PLANNING COMMISSION WORK SESSION MEETING

Tuesday, August 27, 2024 at 7:00 PM

Planning Commission Work Session
SUP 24-01: 71 S. Fifth Street
Car Dealership
August 27, 2024

TO: Casey Squyres, Historic Preservation Planner
FROM: Amber Heflin, CZA, Zoning Official
DATE: July 17, 2024
SUBJECT: Automotive Dealership, 71 S Fifth Street (6984-42-4640-000)
SUP 2024-01
Submission 06/14/2024; 2nd Review

PLAN DATE:	JUNE 3, 2024
DESIGN BY:	AS
CHECKED BY:	JLK
ARCHITECT:	N/A
JURISDICTIONAL PLAN NO.	
RDA PLAN #:	21171-002
SHEET NUMBER:	C.10

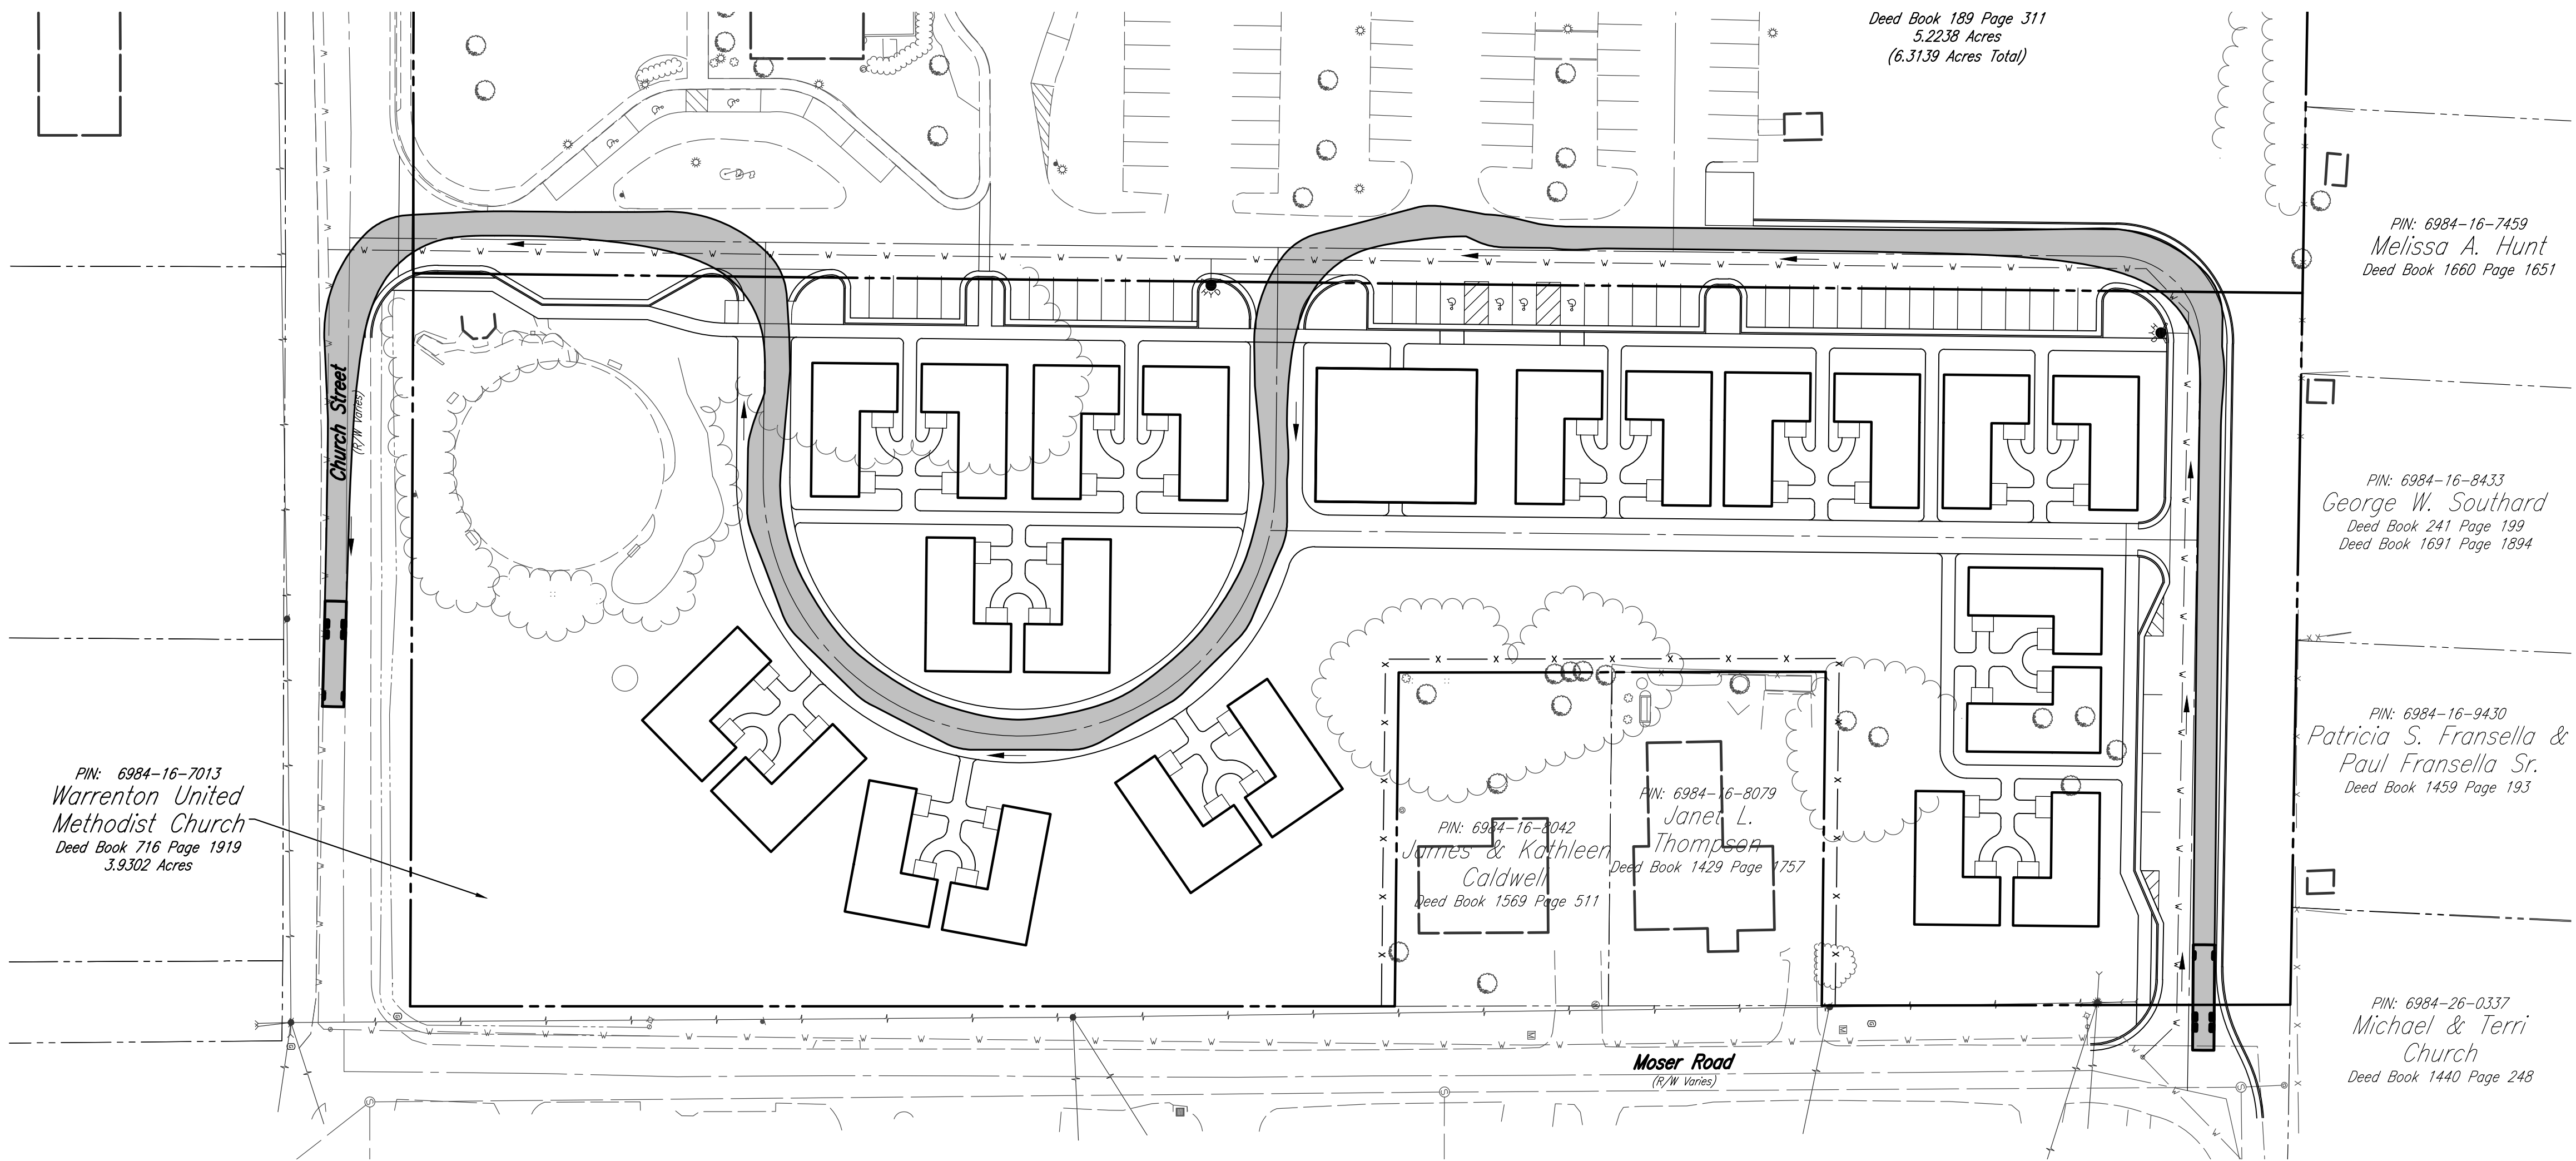
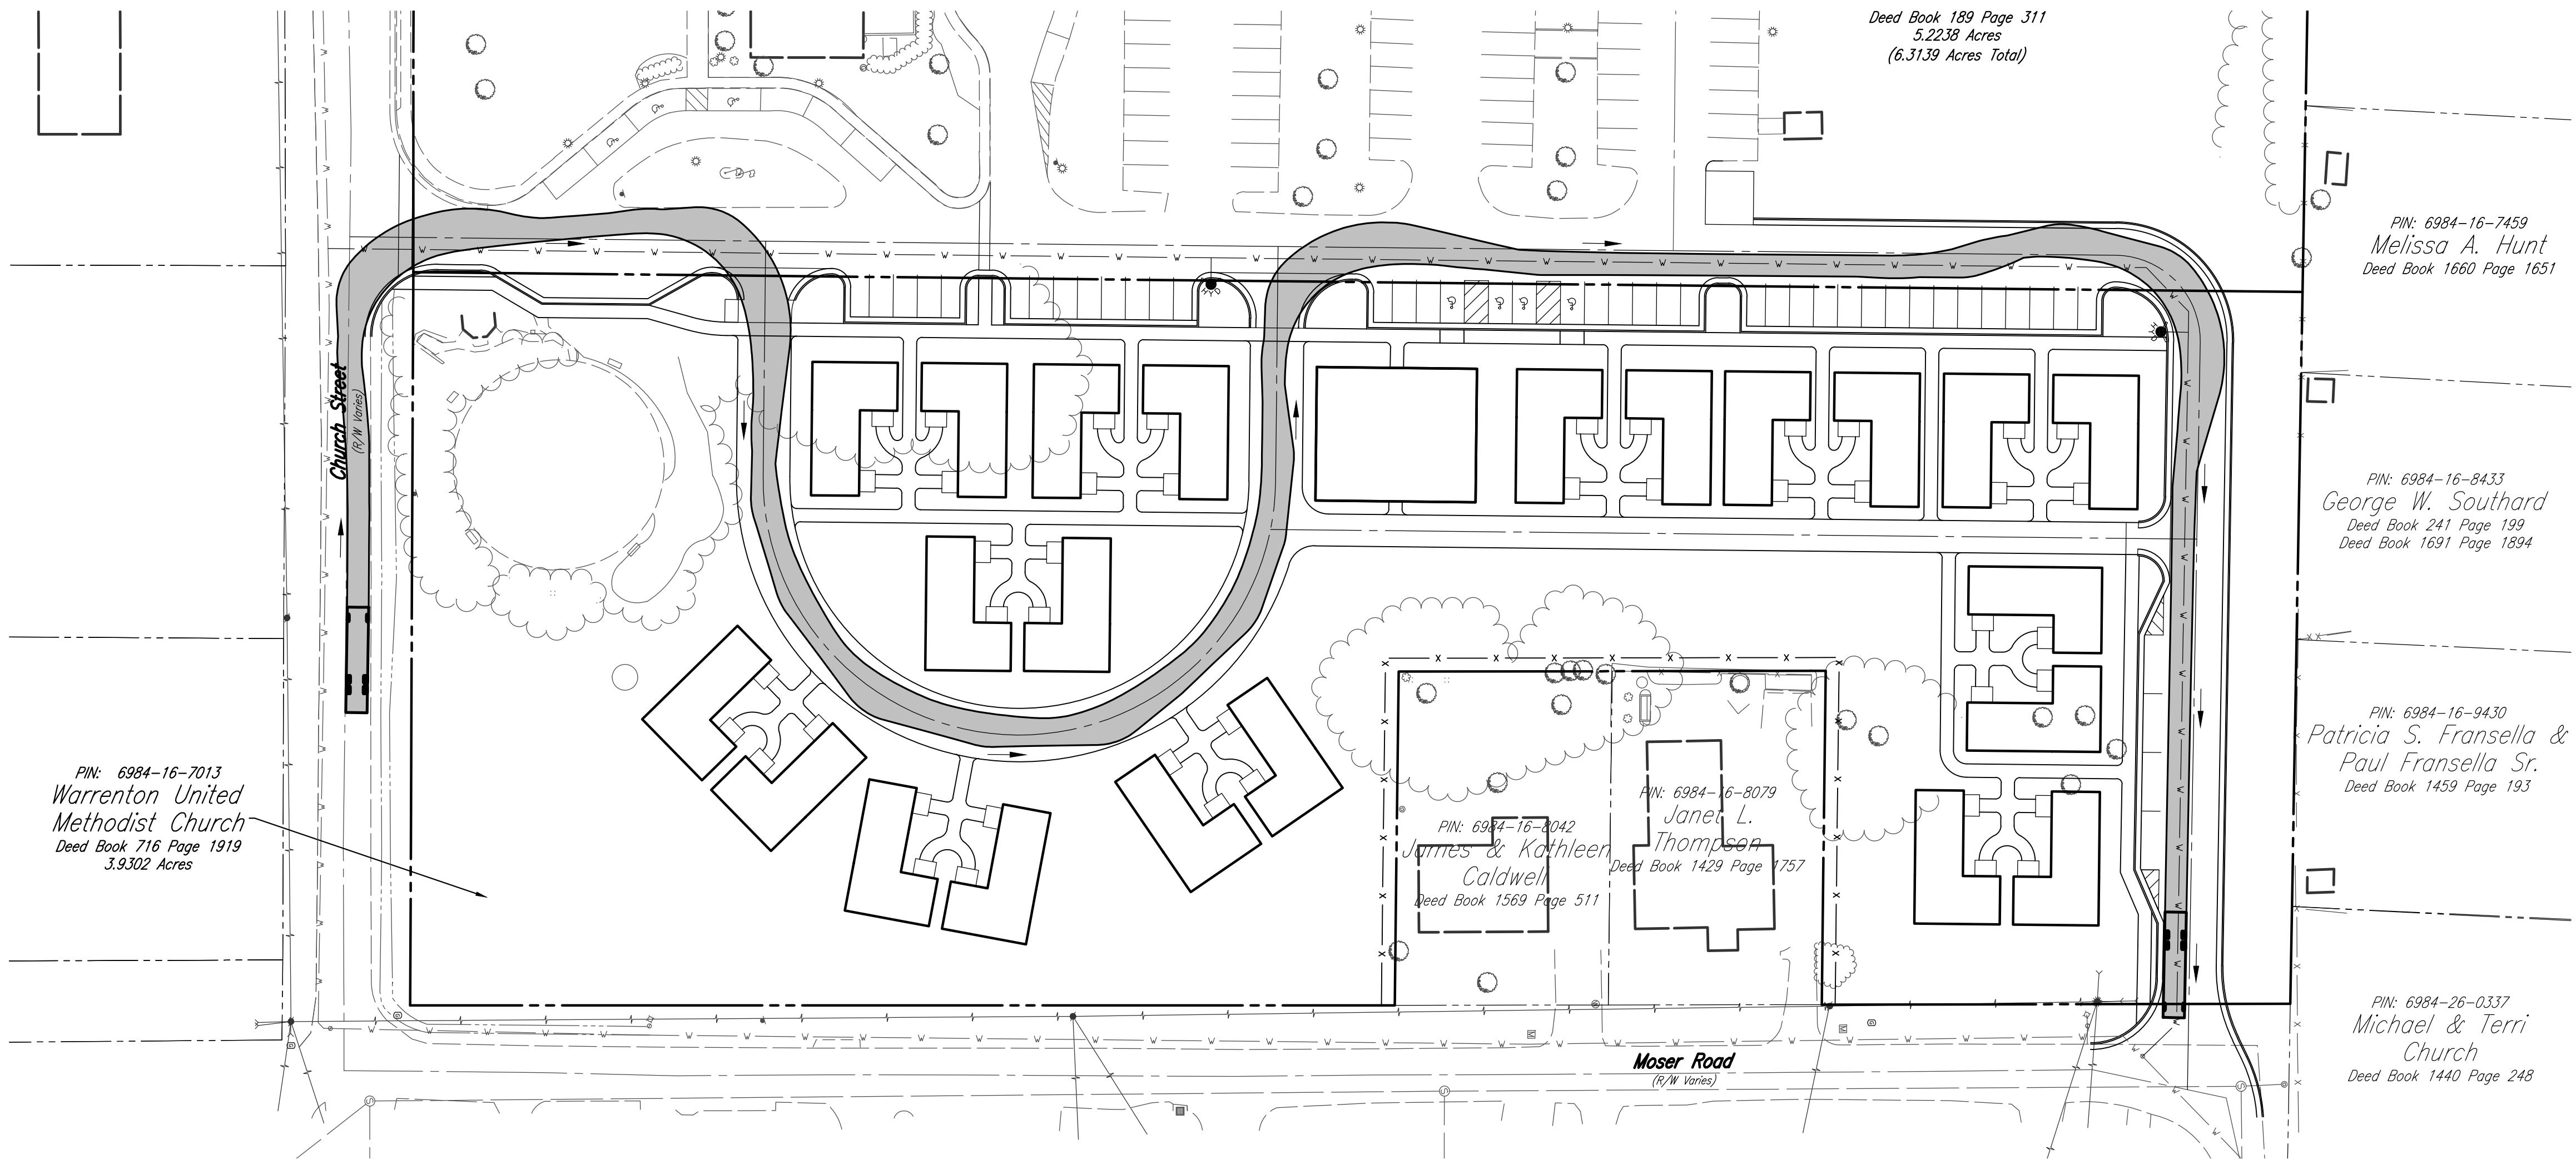
Fire Company, dated January 18, 2024	
Consider wider walkways that will support fire apparatus. We need a width of at least 20' to ensure we can operate an apparatus in the back parts of the development.	Please see the revised GDP (Sheets C.03 and C.04) where the asphalt trail has been widened to 20 feet.
Consider additional fire hydrants to ensure ease of active fire operations.	Please see the revised GDP (Sheets C.03 and C.04) where additional fire hydrants have been added.
Consider requiring residential sprinklers due to the closeness of the occupancies.	If required, sprinklers will be required in connection with site plan and/or building permit review.
Will this space be rentals/transient living or special use?	The homes will be rented.

NOTE: FIRE TRUCK VEHICLE TRACKING PATH CREATED USING
AASHTO 2011 (US CUSTOMARY), SU-40 VEHICLE
(DIMENSIONS=39.5'x8').
